OICA Position Paper/Concern on
draft UN R138.02
after drafting group meeting October 04th, 2023

TF QRTV
08.11.2023

What could be achieved with a bit more time for finding a solution acceptable to all stakeholders

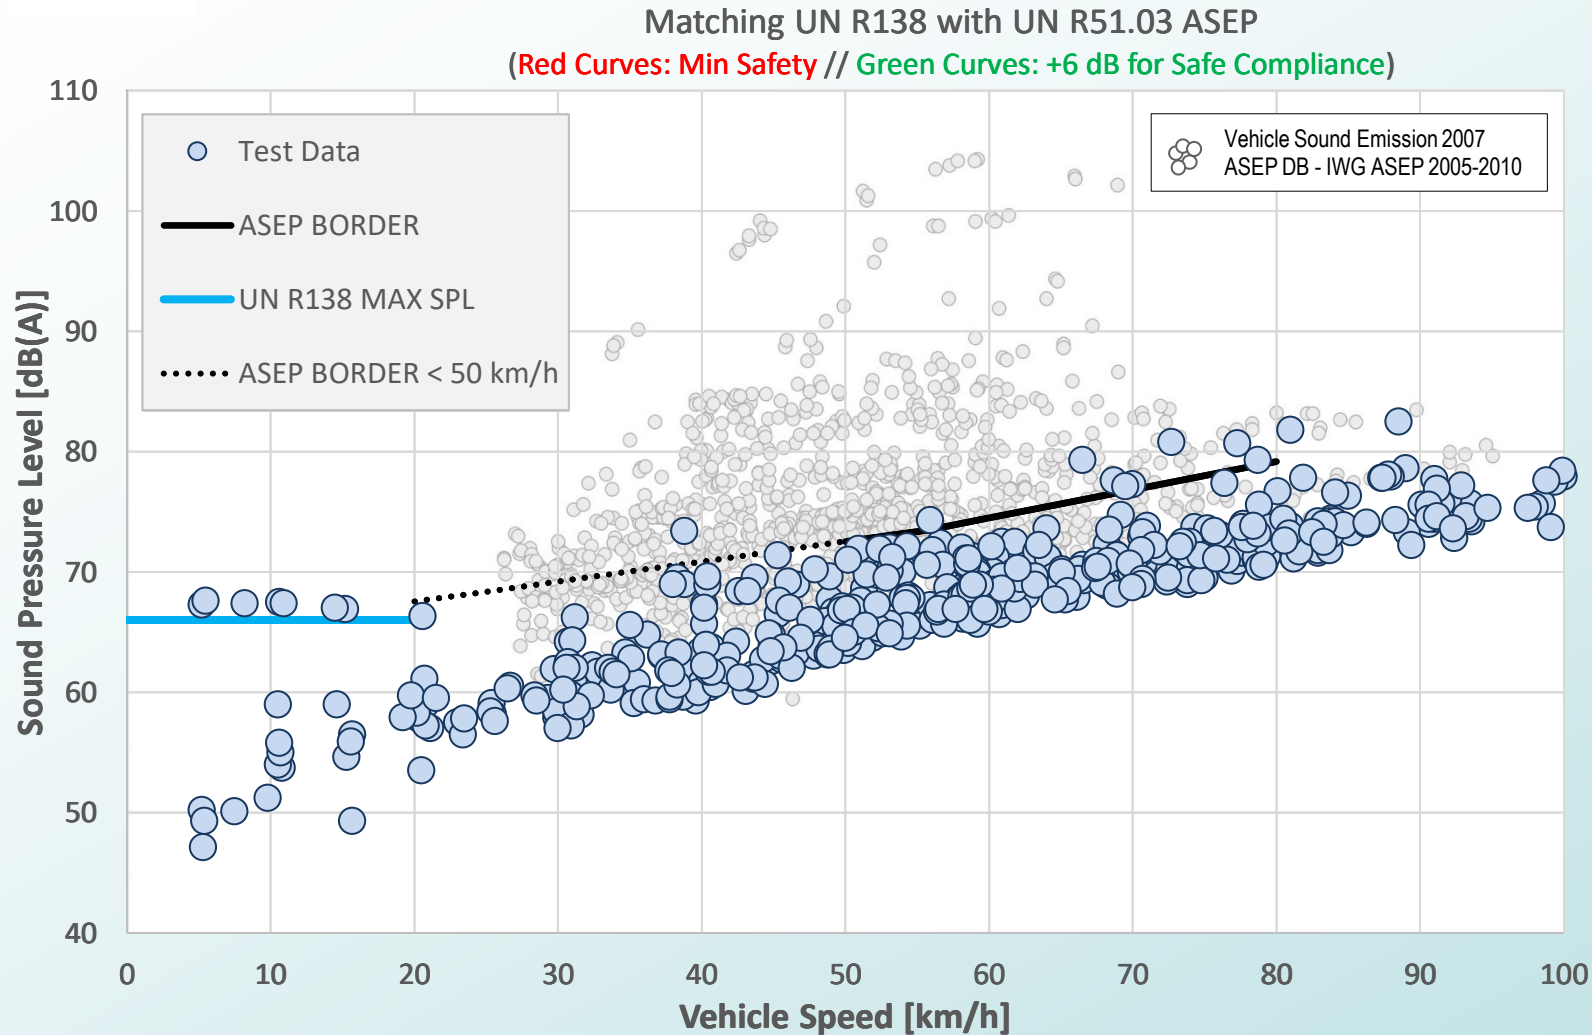
- OICA proposal can be applied sooner by splitting safety and environment requirements by supplement in each regulation (R51 and R138).
 - Avoid regulatory conflict between safety and environmental aspects – sufficient margin between sound levels for R138 and R51.
Each discipline requires individual scientific approaches and testing methods.

- Update R51 with a supplement to include electric vehicles with ASEP in Annex 7
 - Operation range is determined by environmental considerations.
 - The maximum level and speed range is covered by R51.03 Annex 7

- Update draft for R138 to work as a supplement – remove anything that requires a new series:
 - Delete ambiguous definition “artificial sound” and “natural sound”
 - Consistently address whole vehicle sound throughout the text
 - Avoid requirement for manufacturer compliance statements without test procedures
